CITY OF ALBUQUERQUE PUBLIC WORKS DEPARTMENT		RECEIVED SEP 10 2007	
TITLE: ANDERSON HEIGHTS UNIT 9 GRADING AND DRAINAGE PLAN			
DESIGN REVIEW COMMITTEE	CITY ENGINEER APPROVAL	MO./DAY/YR.	MO./DAY/YR.
CITY PROJECT NO. 753981		ZONE MAP NO. N-8/P-8	SHEET OF 7R 83

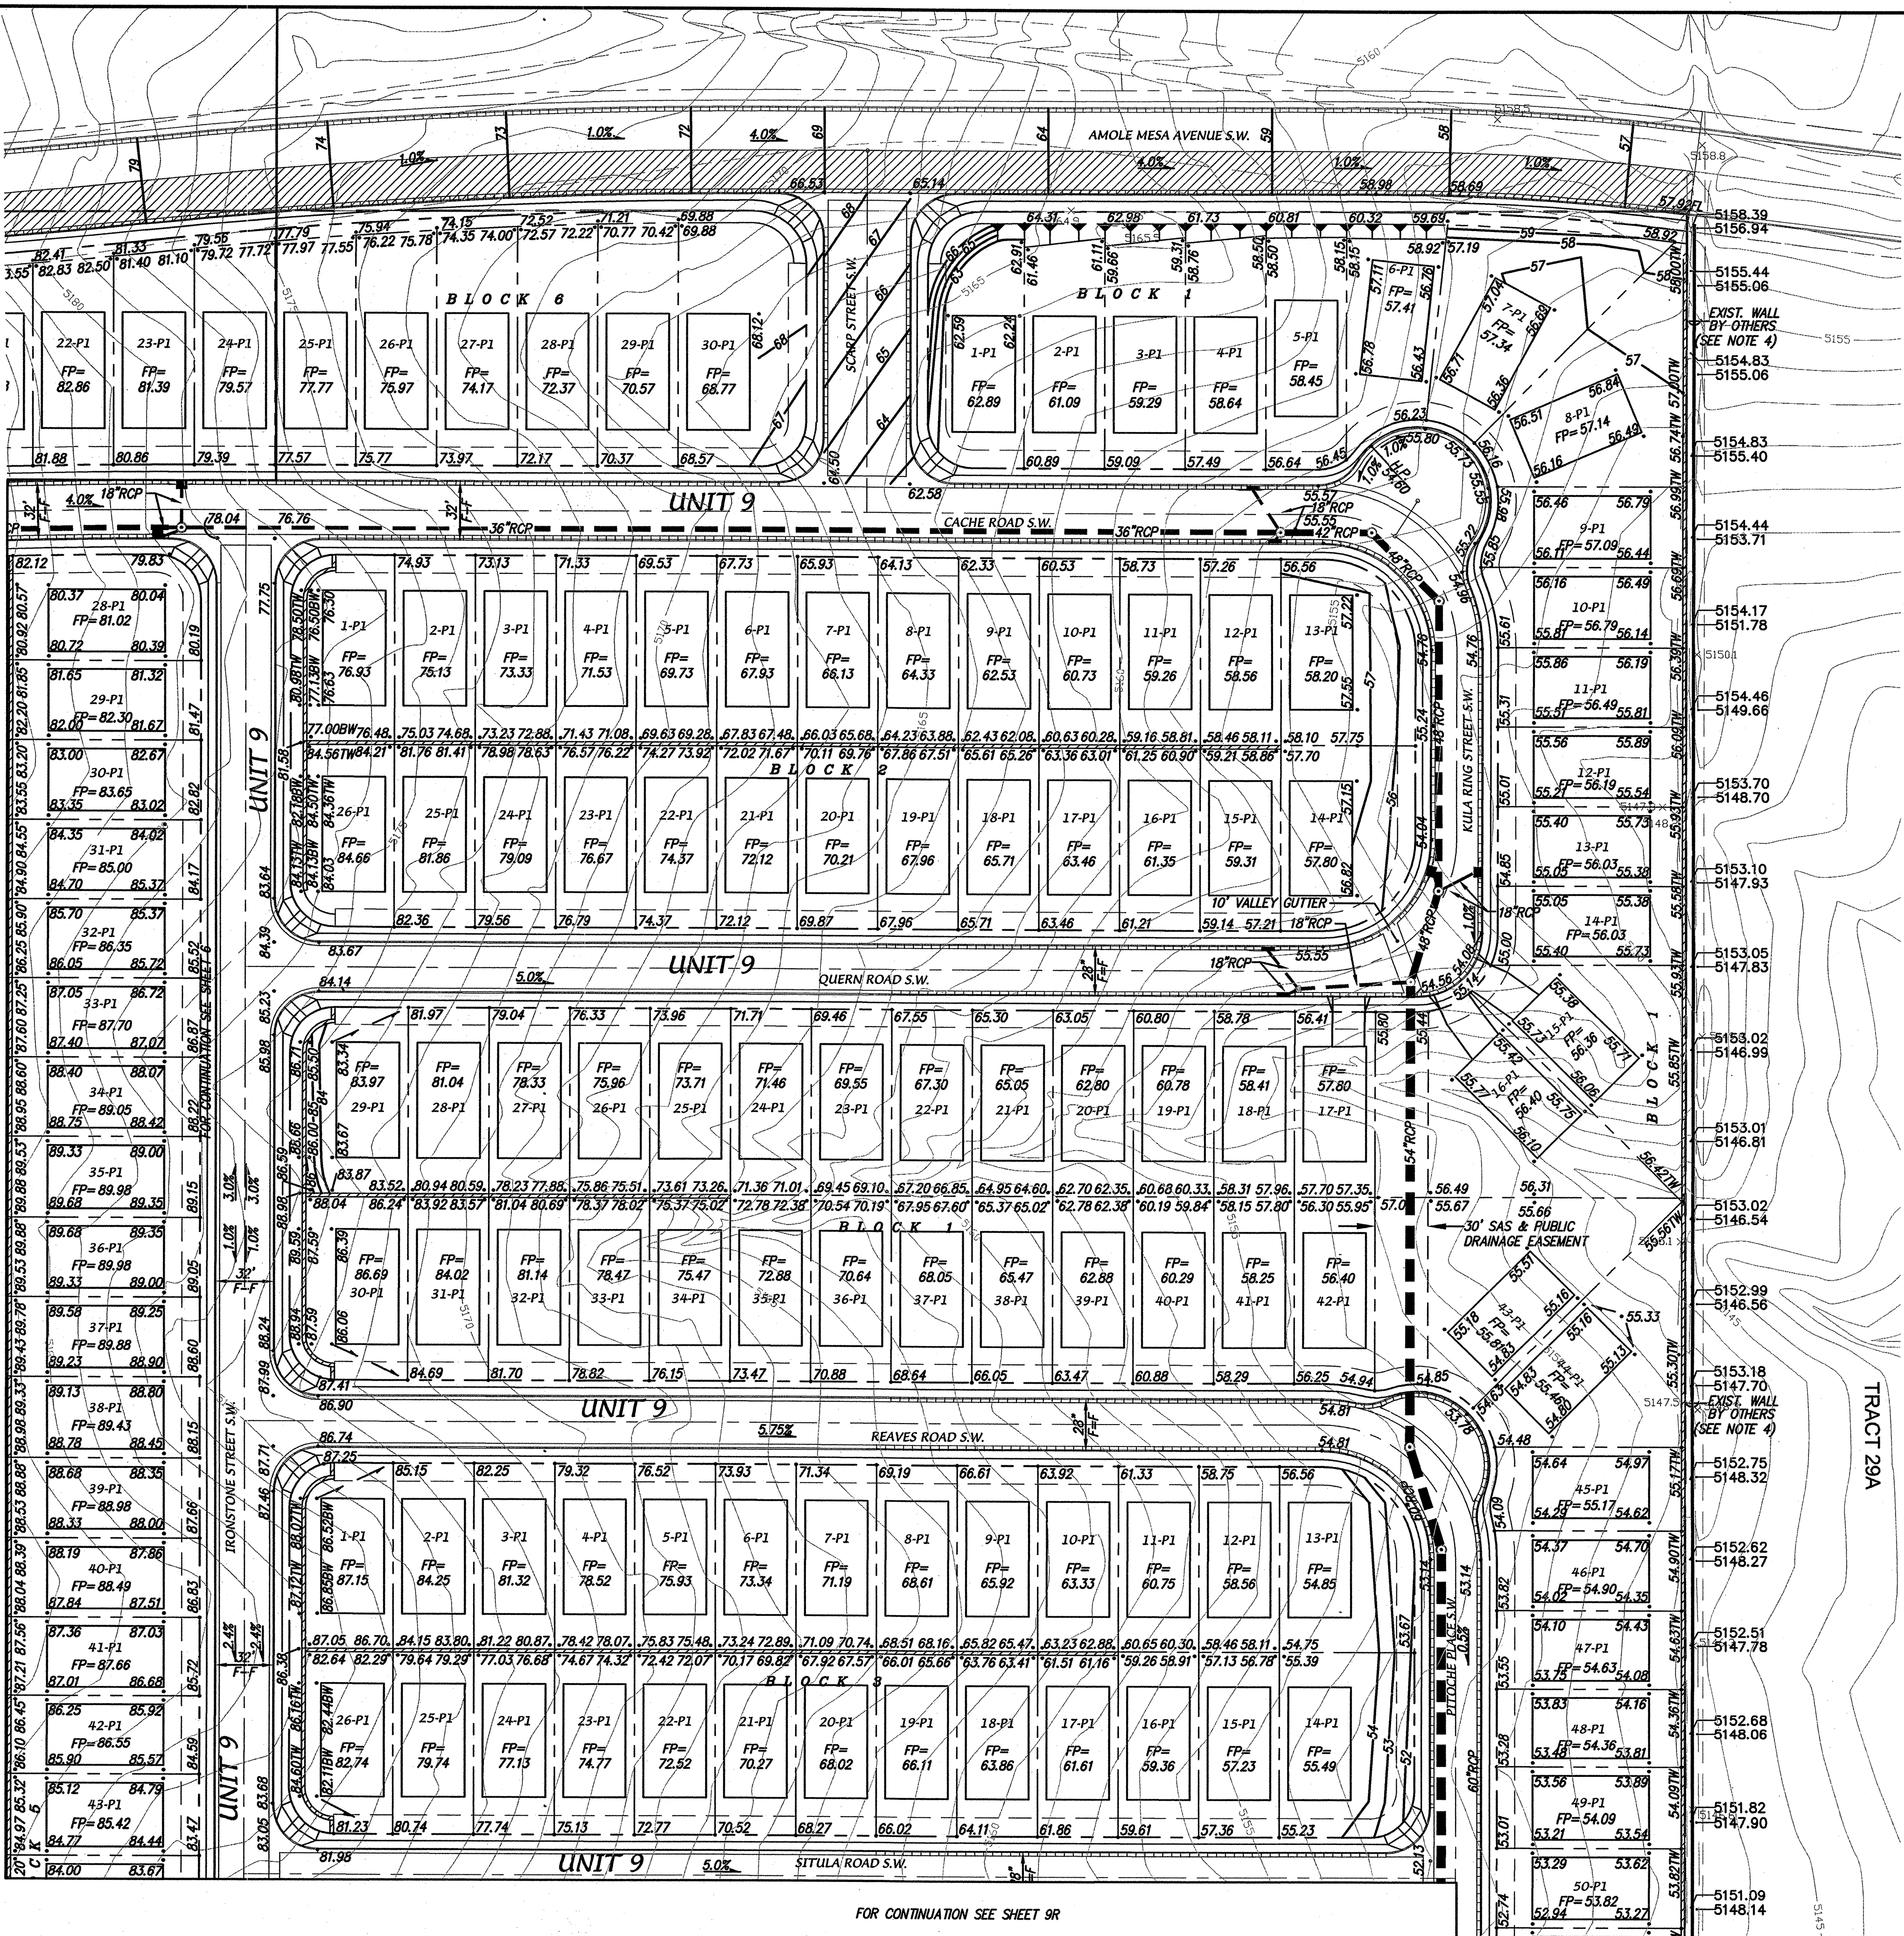
NOTE 3: UNIT 9 GRADING PLAN REVISED TO ACCOMMODATE MINIMUM COVER OVER STORM DRAIN AND DRC TRANSPORTATION COMMENTS.
